CE-06-16
December 16, 2005

SPECIAL AIRWORTHINESS INFORMATION BULLETIN

Title: MAIN LANDING GEAR – BOLT FITTING INSPECTION AND REPLACEMENT

Figura 1 - REMOVAL OF BUSHING P/N MB 06-10DU

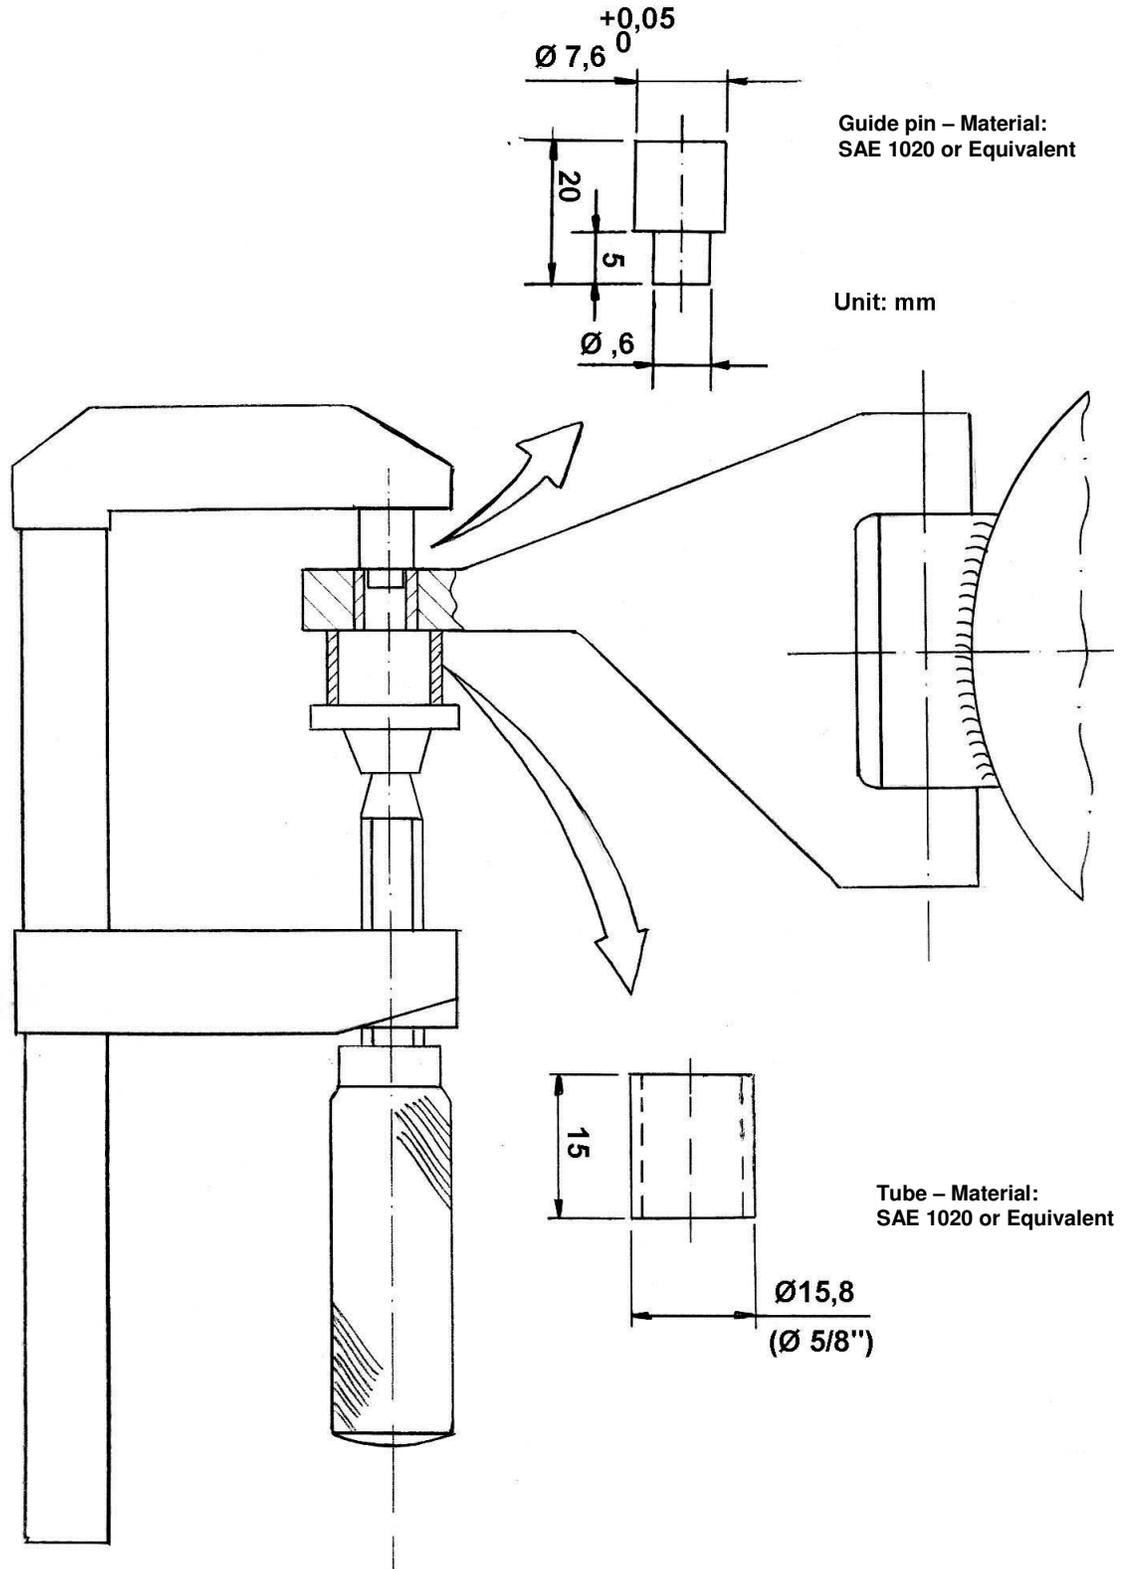
- 2.2.1 Check if the parking brake is applied and install the wooden wedges at the main landing gear wheels.
- 2.2.2 Remove bolts P/N UNBRAKO-6, washers P/N ZU-5 and ZU-6, spacers P/N 32374 and nuts P/N 5PA-108 from torque link assembly of main landing gear (LH and RH).
- 2.2.3 Clean the torque link assemblies (LH and RH).
- 2.2.4 Remove bushings P/N MB 06-10 DU from torque links using tool as shown in figure 1 or other equivalent method.

Figura 2 -INSTALLATION OF BUSHING P/N 32392

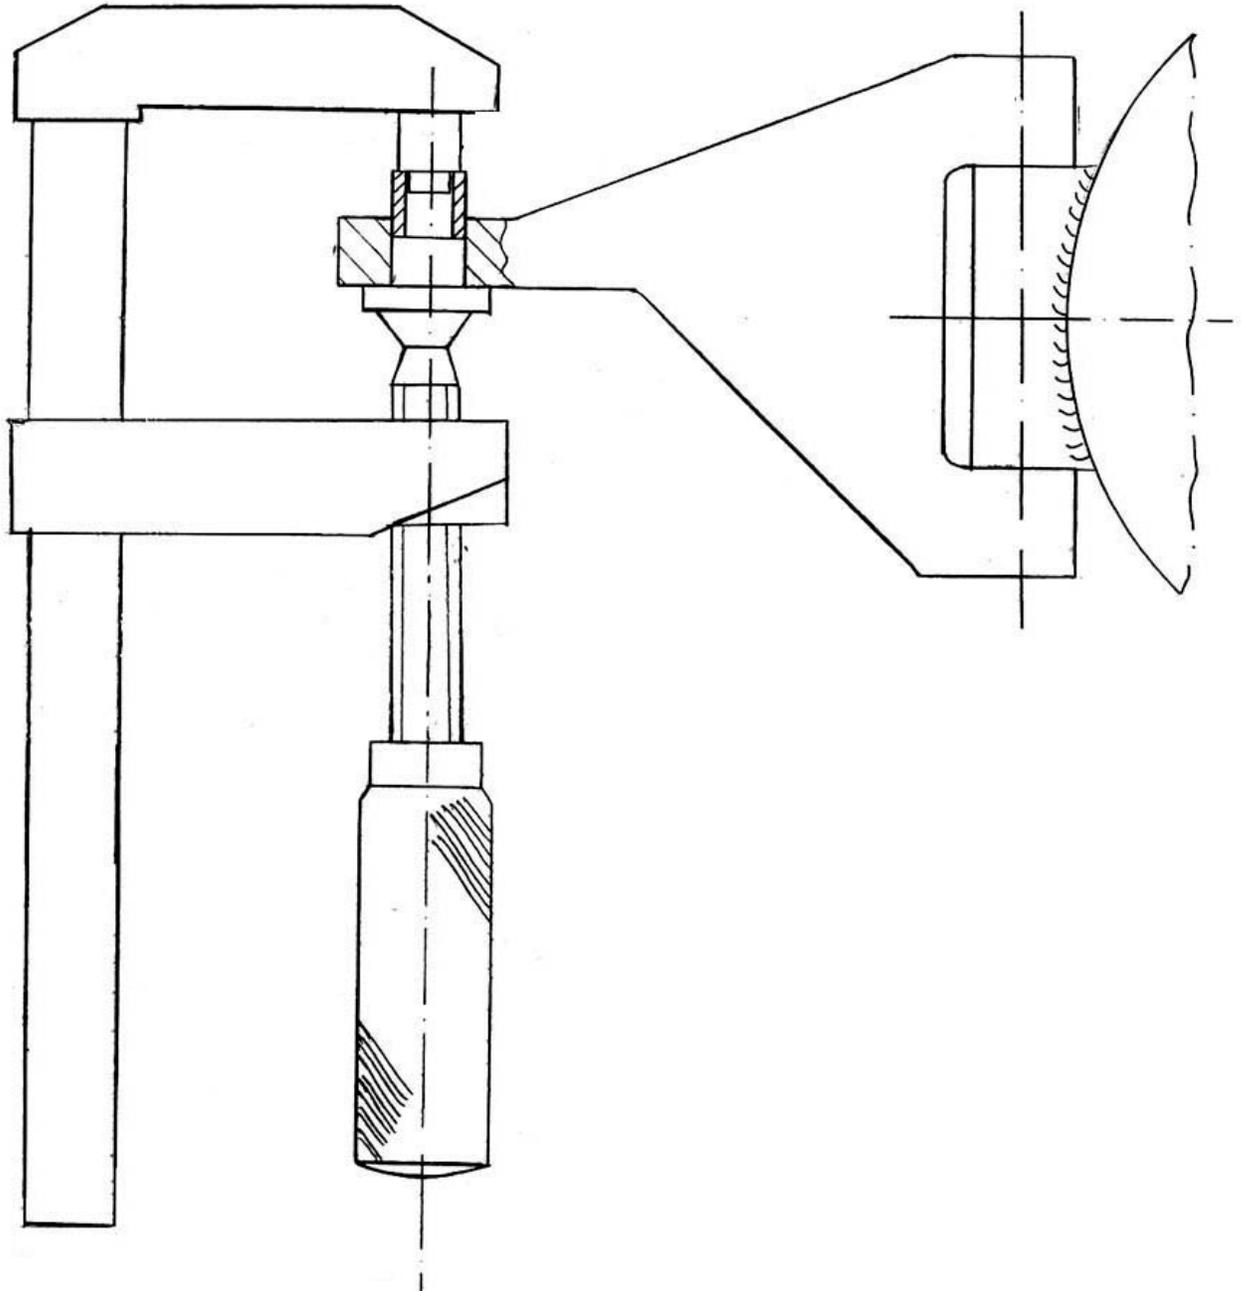
- 2.2.5 Install new bushings P/N 32392 using the same tool as shown in figure 2 or other equivalent method.
- 2.2.6 Install at torque links of main landing gears (LH and RH), bolts P/N AN4-13, spacers P/N 32391, washers P/N AN960-416, nuts P/N AN310-4 and lock them with cotter pins P/N AN380-2-3 assuring a clearance of 0,1 to 0,3 mm between the torque link, as shown in figure 3.
- 2.2.7 Record the Service Bulletin application in the Airframe Log Book.
